Responses to Comments on Updated Study Report and Updated Study Report Meeting Summary

Yuba River Development Project FERC Project No. 2246

RESPONSE TO COMMENTS ON UPDATED STUDY REPORT

Figure 2.1.4-1. Flow and detections at Camptonville Diversion Tunnel. Note that maximum diversion capacity is 1,100 cfs.

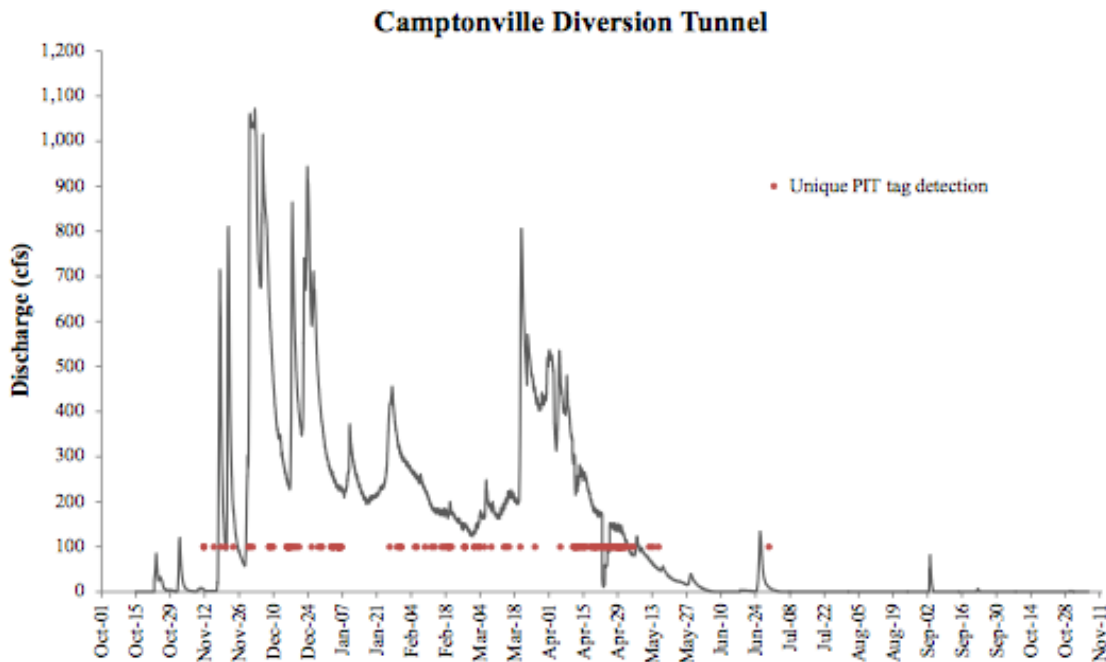
Cal Fish and Wildlife suggests that the 2012 and 2013 monitoring years were unrepresentative due to the water year type. For clarity, 2012 was below normal and 2013 was a dry water year. During these periods, the study monitored flows that exceeded 1,000 cfs and were representative of a full range of diversion rates. Figures 2.1.4-1 and 2.1.4-2 show flow and detection at Camptonville (capacity 1,100 cfs) and Lohman Ridge (capacity 860 cfs) tunnels. Both tunnels reach maximum diversion capacity during the monitoring year. Further, a series of studies were conducted that were all flow-dependent and considered representative of Project conditions.

Figure 2.2.3-1. Conceptual layout of YCWA’s proposed new Flood Control Outlet and areas that would be affected by construction of the outlet. [from Figure 2.2-5 in Exhibit E in YCWA’s December 2, 2013 DLA.]

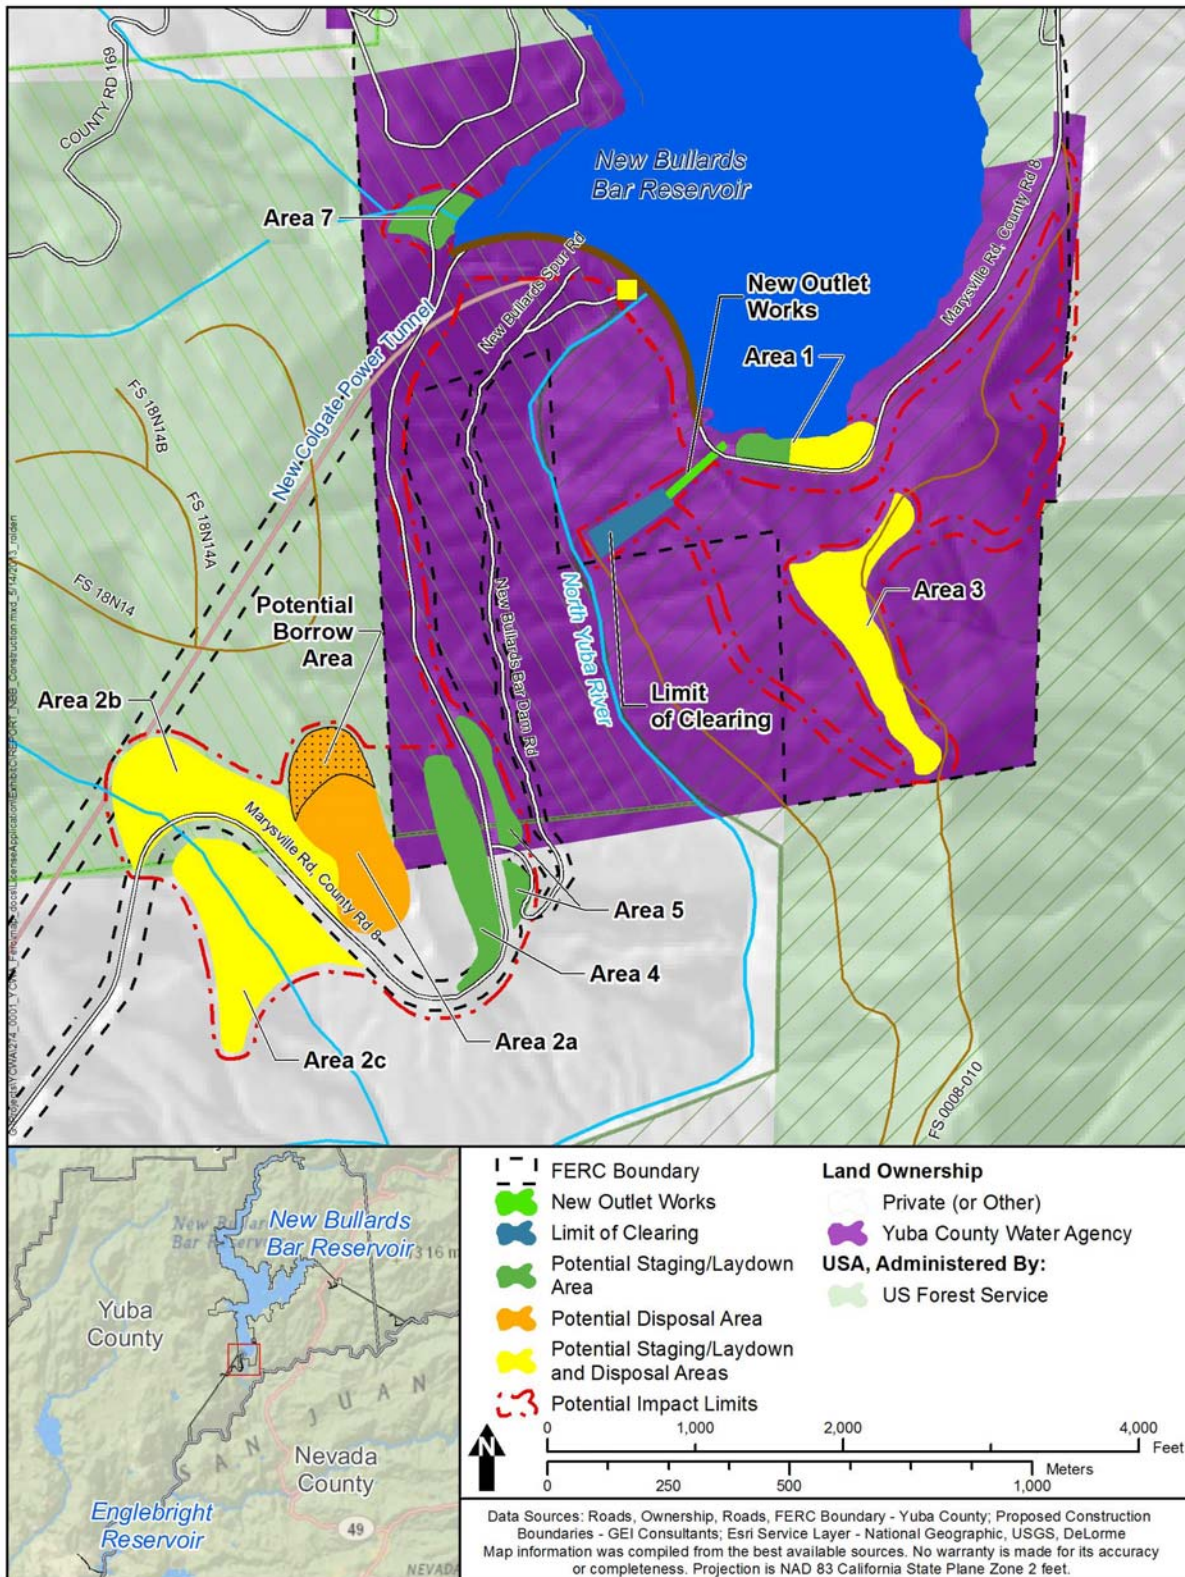
The Forest Service bases its request, in part, on its contention that “*No studies were previously designed to assess effects of construction on NFS lands and provide operational scenarios.*” (Page 9 of Attachment 1 to the Forest Service's January 30, 2014 letter). Cal Fish and Wildlife bases its request, in part, on its contention that that “*No studies were previously designed to assess effects of construction on fish, wildlife and plant resources, and provide operational scenarios.*” (Page 18 of Cal Fish and Wildlife's January 30, 2014 letter).

First, YCWA must clarify that, except for small portions of potential borrow areas 2a, 2b and 2c, the proposed new Flood Control Outlet does not affect NFS land. As shown in Figure 2.2.3-1, the entire facility and the area potentially affected by construction are located on YCWA-owned or privately-owned land. Further, there is no NFS land downstream of New Bullards Bar Dam. Therefore, the only areas that directly affect NFS land are those small portions of potential borrow areas 2a, 2b and 2c.

Second, both the Forest Service and Cal Fish and Wildlife incorrectly state that the existing FERC-approved studies do not provide information regarding resources potentially affected by construction, operation and maintenance of the new Flood Control Outlet. Table 2.2.3-1 lists how each of the FERC-approved studies, for which the Forest Service and Cal Fish and Wildlife request “*developing targeted surveys and/or mapping efforts,*” provide information relevant to the new Flood Control Outlet.
